Simulink/Front Model & MEDM Screen Mods from ECR E1300578 (For SUS' in BSC Chambers)

J. Kissel for the SUS and ISC Team

G1301192-v3

Divided up Commissioning vs. Science Frames

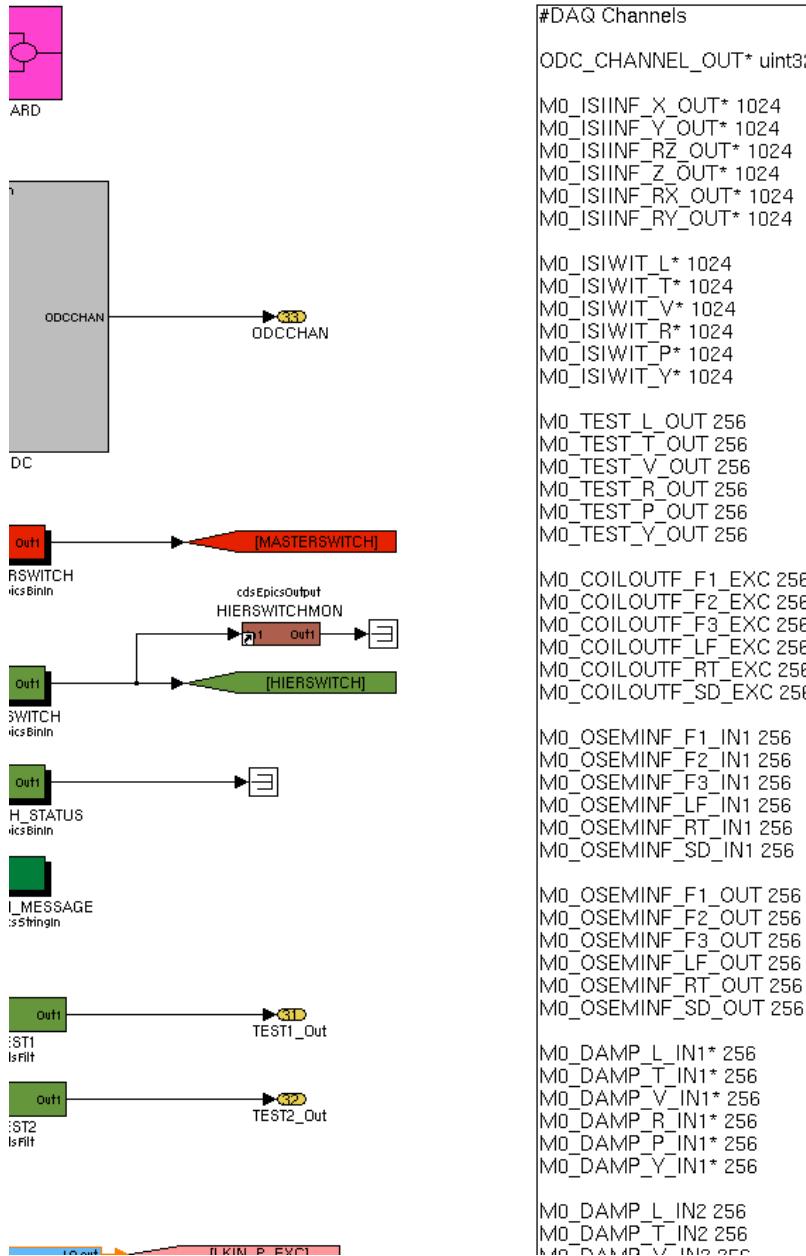
Chose to store forever:

- One SUS/BSC-ISI's worth of Calibrated Cartesian Basis in [nm / nrad] **\$(IFO):SUS-\$(OPTIC)_\$(M0/M1)_ISIINF_\$DOF_OUT_DQ** i.e. the QUADs and the BSFMs are in charge of storing this
- Every SUS' Calibrated suspension point motion [nm / nrad]
- Only one version of OSEM / Oplev / ISC sensor signal at each stage – Euler basis, Calibrated into [um / urad]
- Only one version of control signal at each stage – OSEM basis, (uncalibrated) DAC counts

Removed QUAD lower stage damping

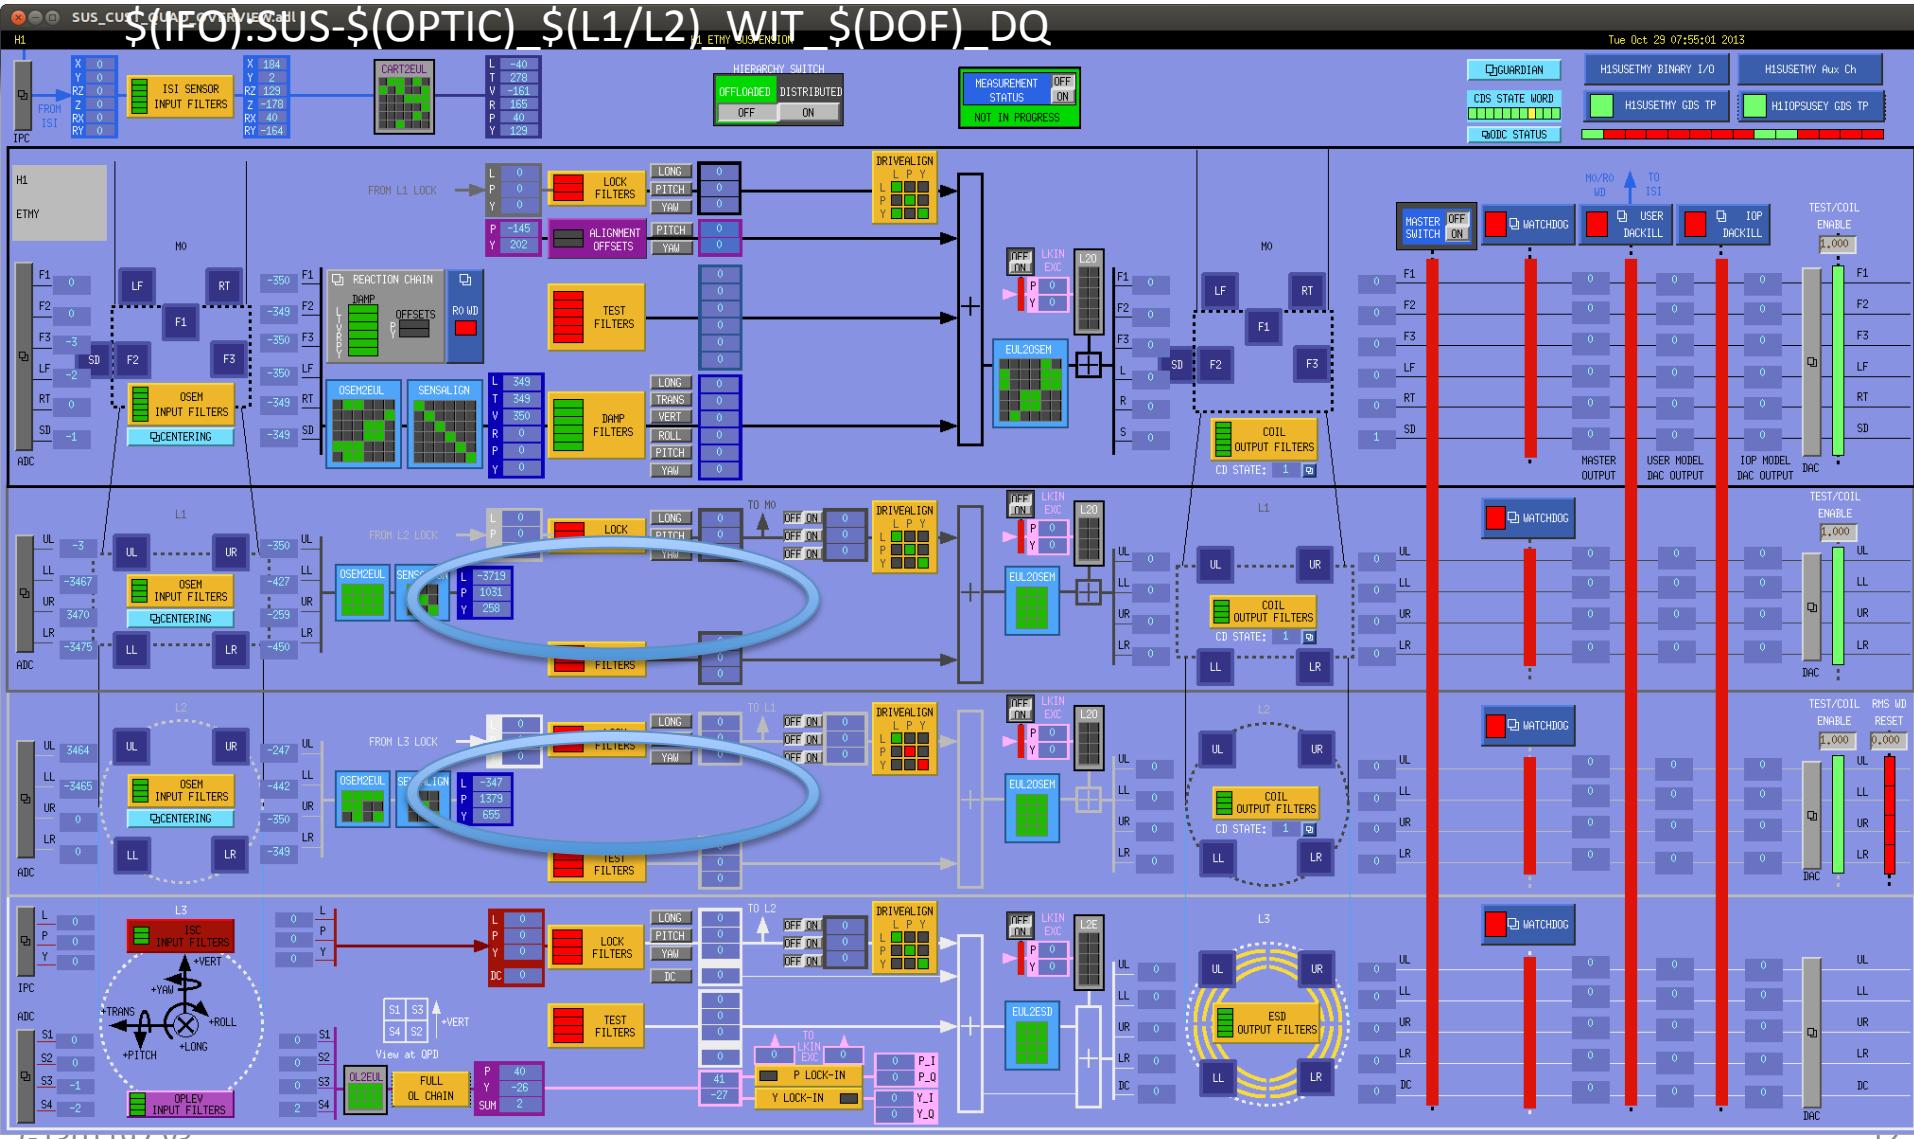
- No longer needed now that ISIs are commissioned
- Means \$(IFO):SUS-\$(OPTIC)_\$(L1/L2)_DAMP_\$(DOF)_IN1_DQ becomes \$\$(IFO).SUS-\$(OPTIC)_\$(L1/L2)_WIT_\$(DOF)_DQ

Added Optical Lever LOCK-IN

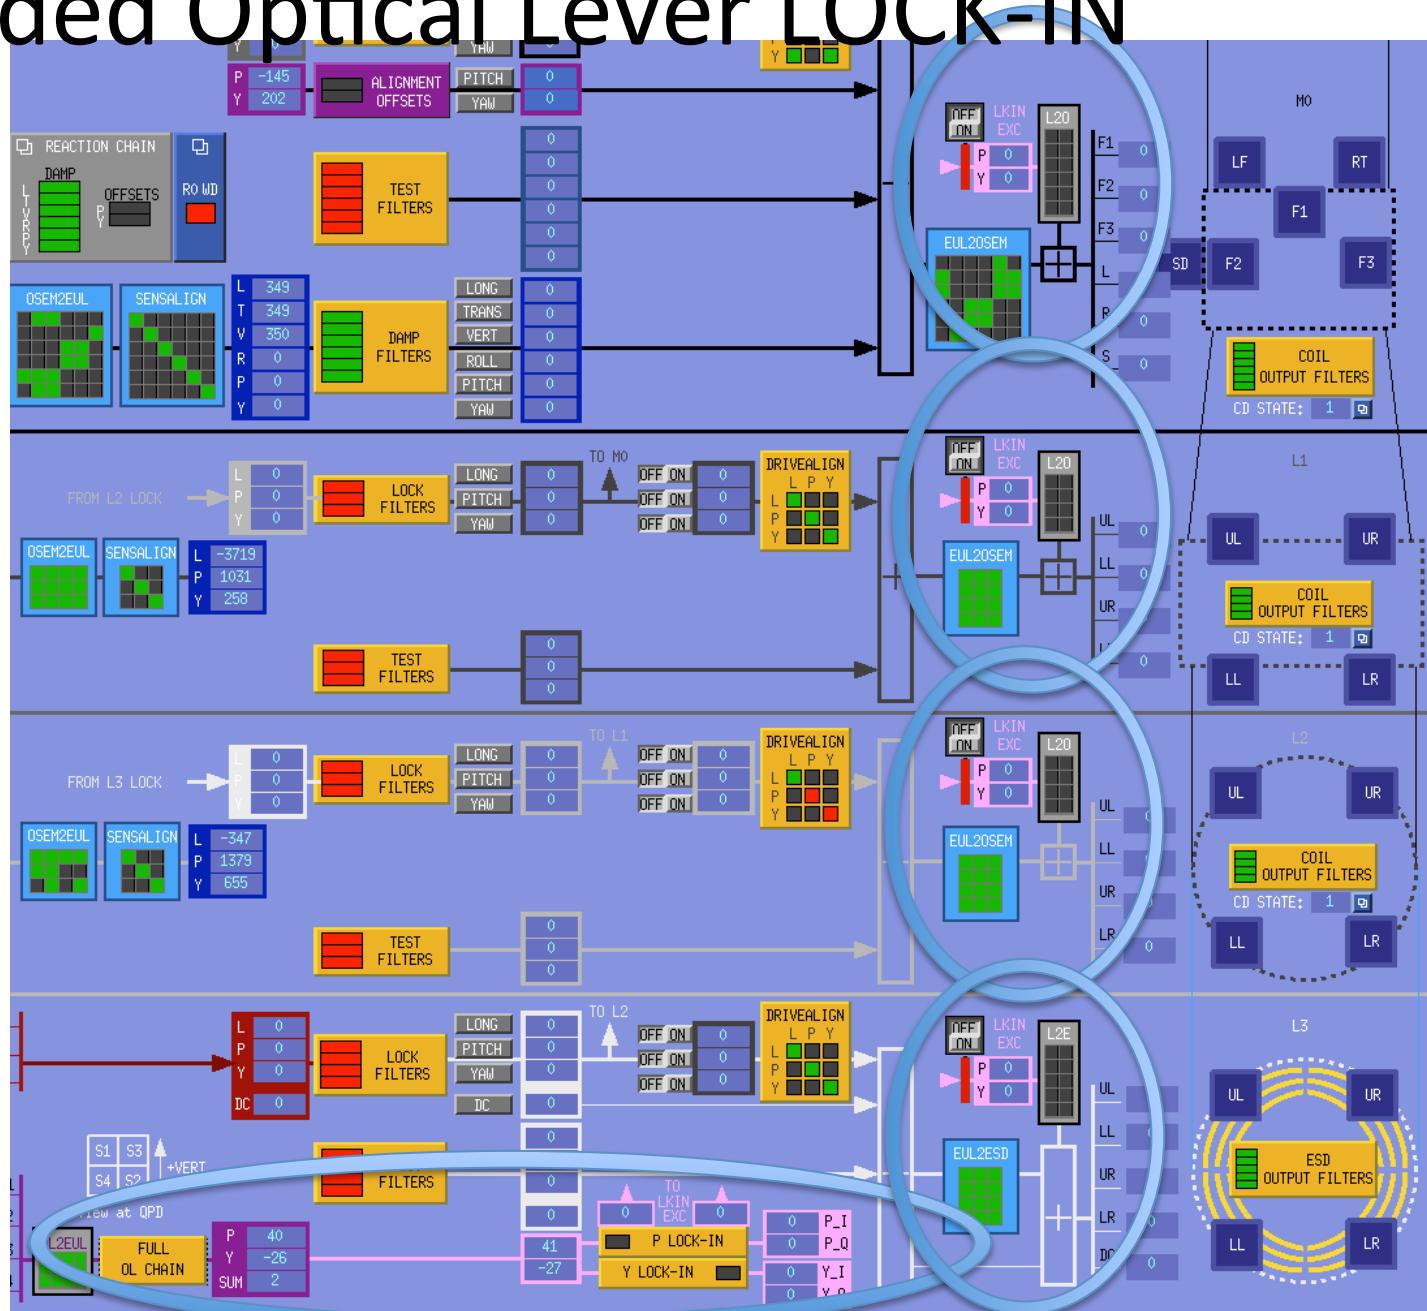
- Sent directly to coil basis, so we can do any configuration we want
- Sent to every stage
- One for PITCH, and one for YAW

Added Optical Lever LOCK-IN

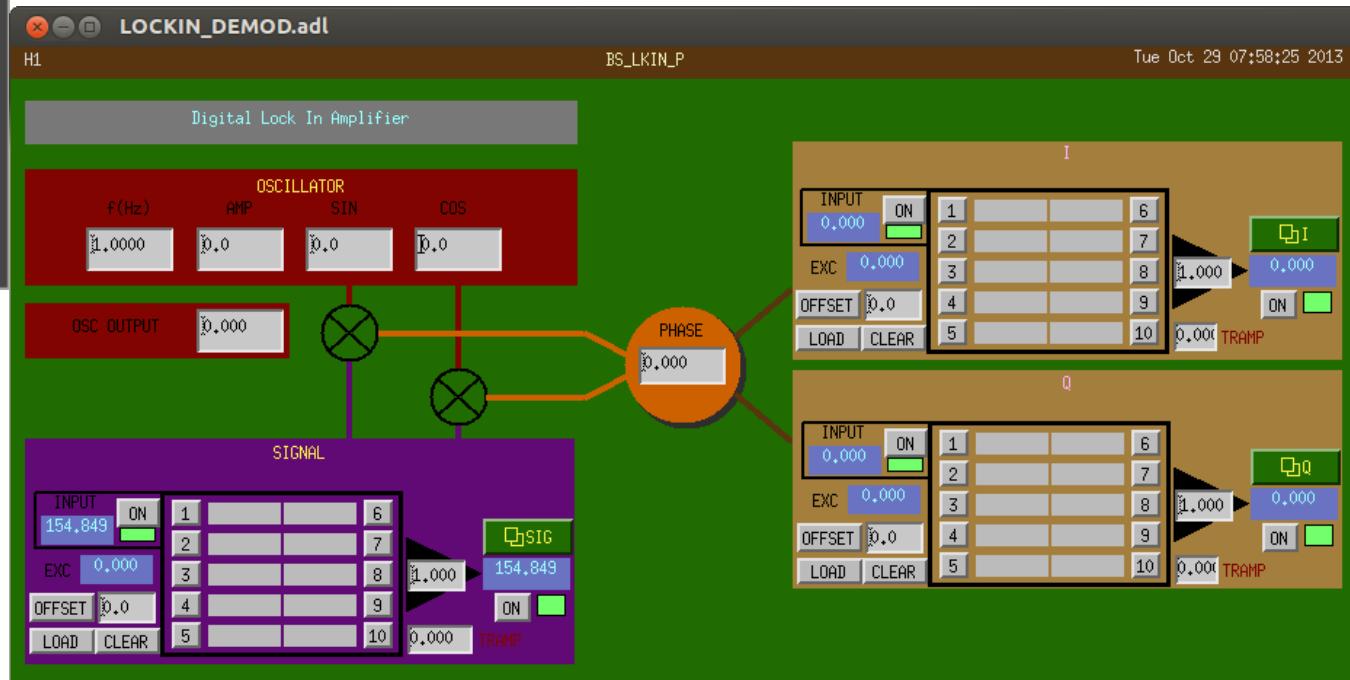
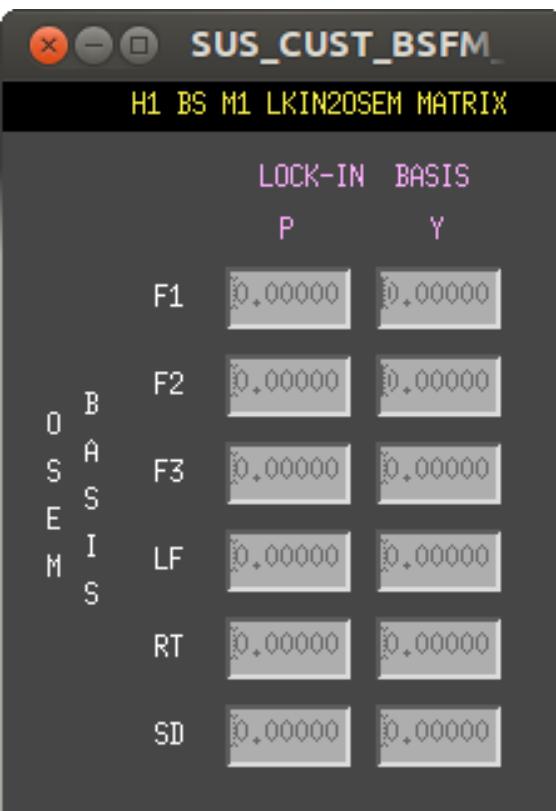
- Sent directly to coil basis, so we can do any configuration we want
- Uses ISC library part
- **Needs new \$(SUBSYSTEM) and \$(INSTANCE) variables in macro files**

Added CDS STATE Word and ODC Screen Link

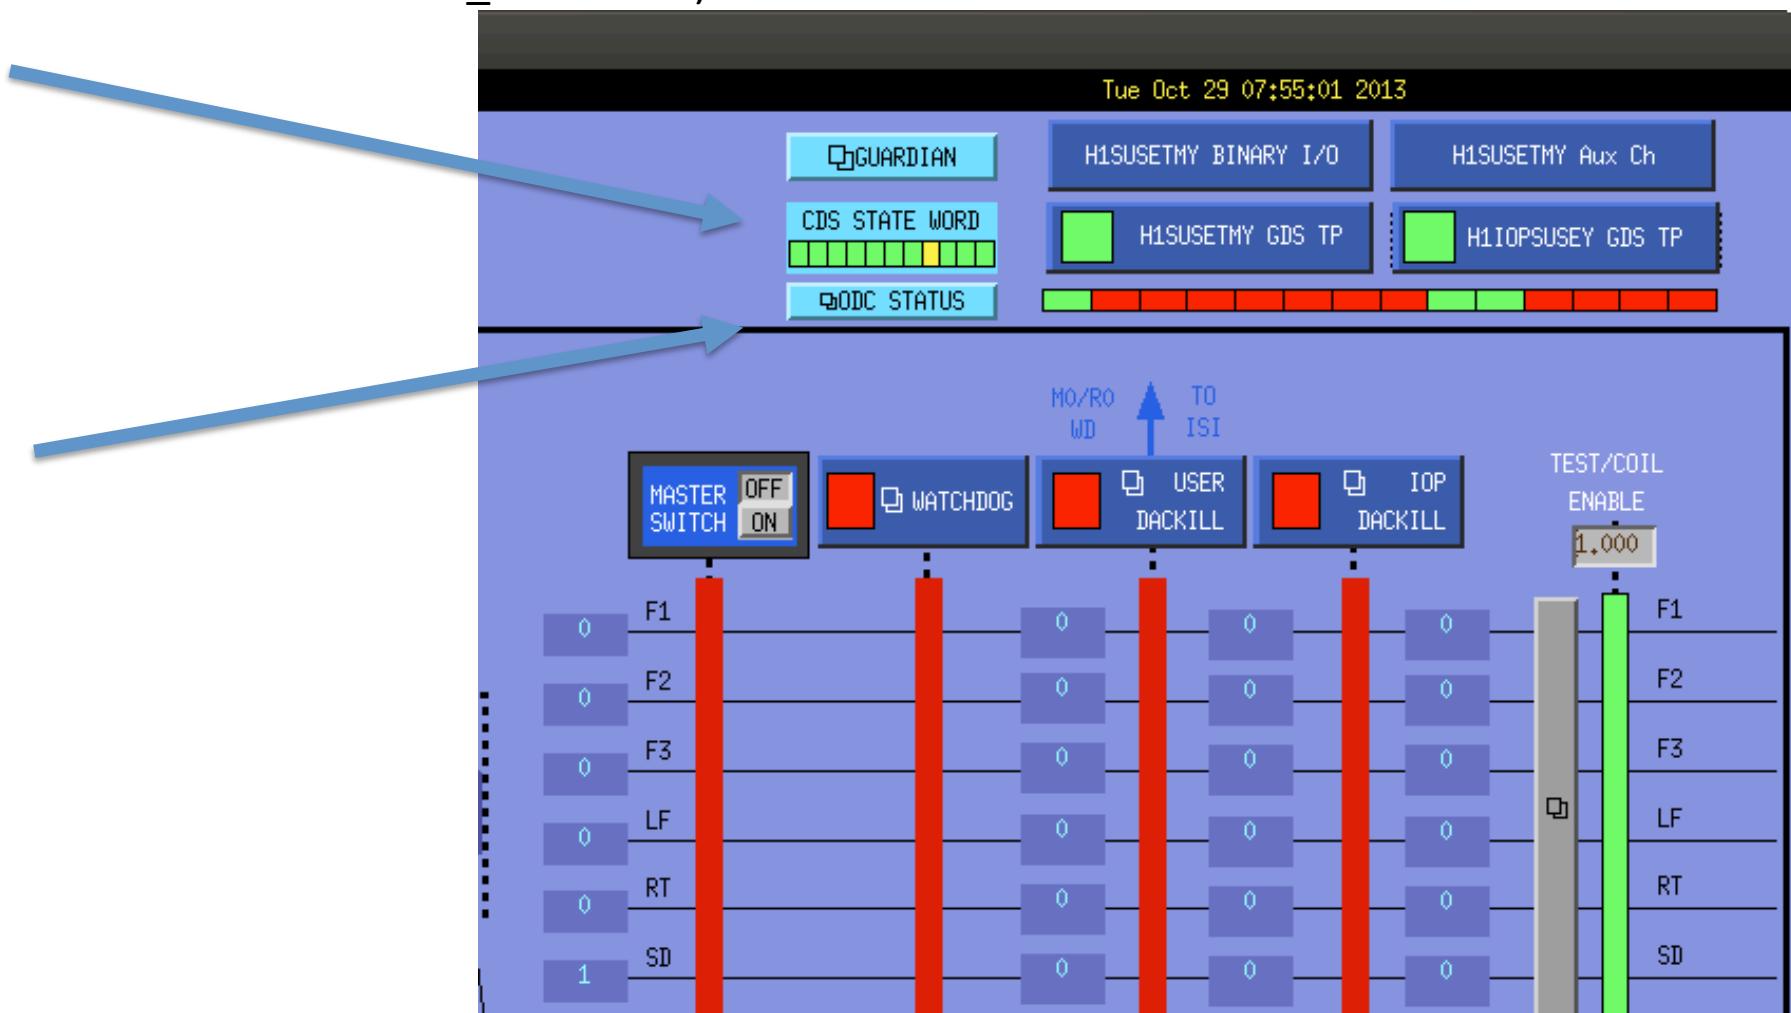
Shows the health of the CDS system
(which is *not* on the GDS_TP screen!)

Accumulate Individual Overflows

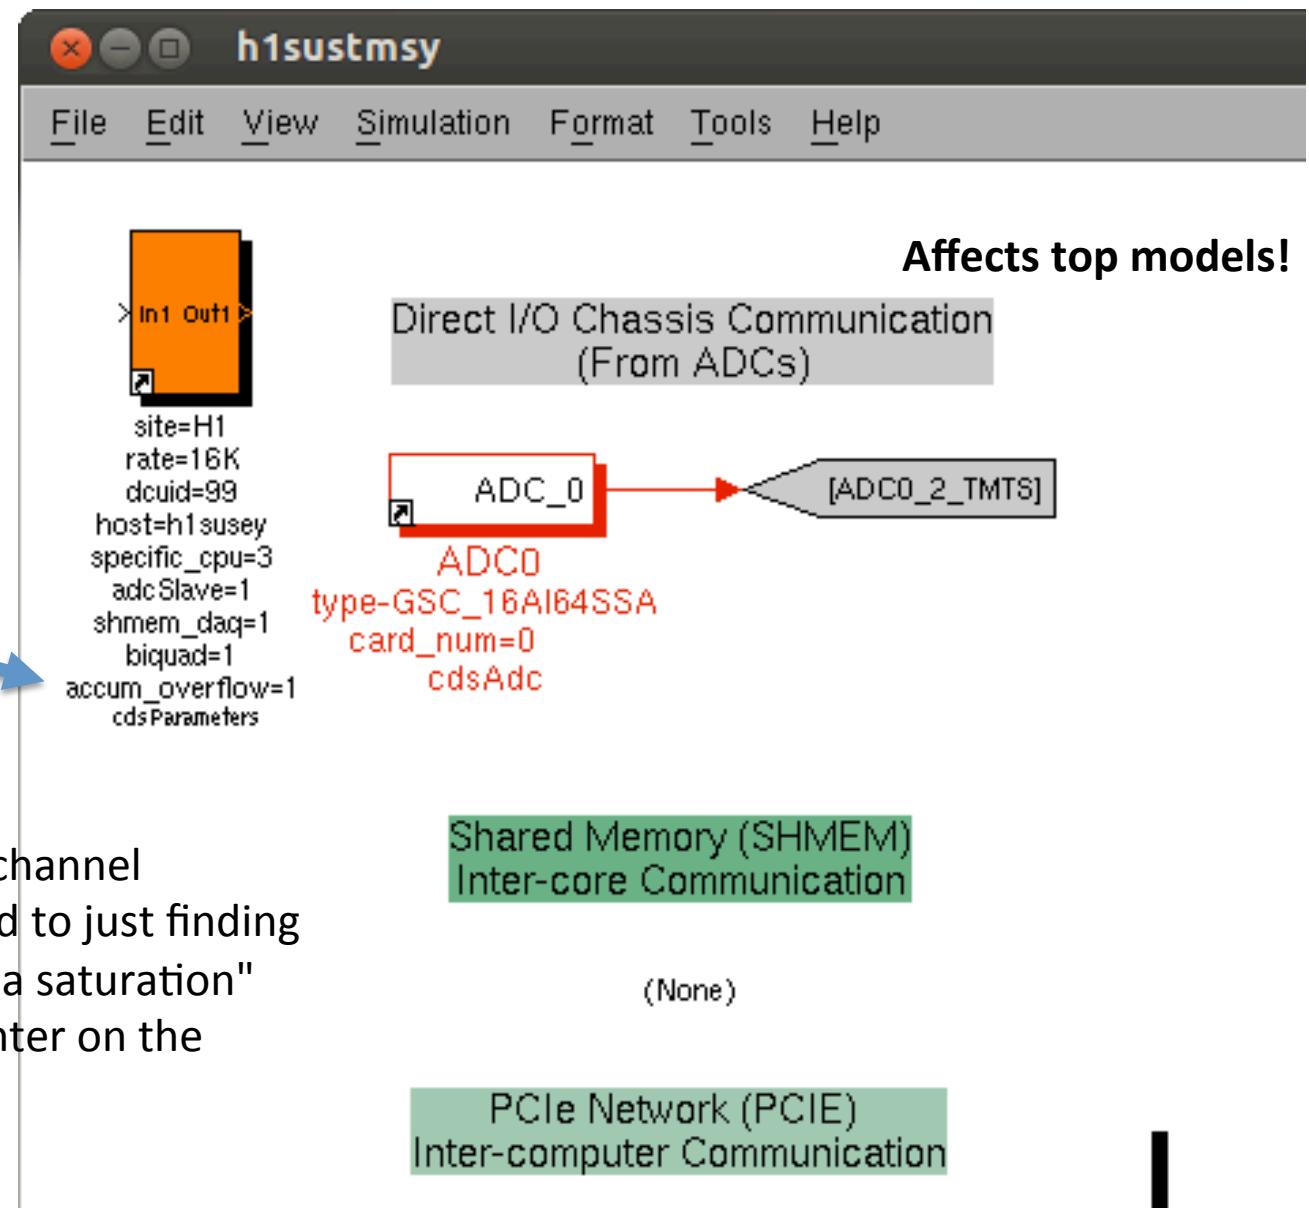
- changes the overflow counters for each DAC and ADC channel to accumulate until the reset button is hit (as opposed to clearing once a second)
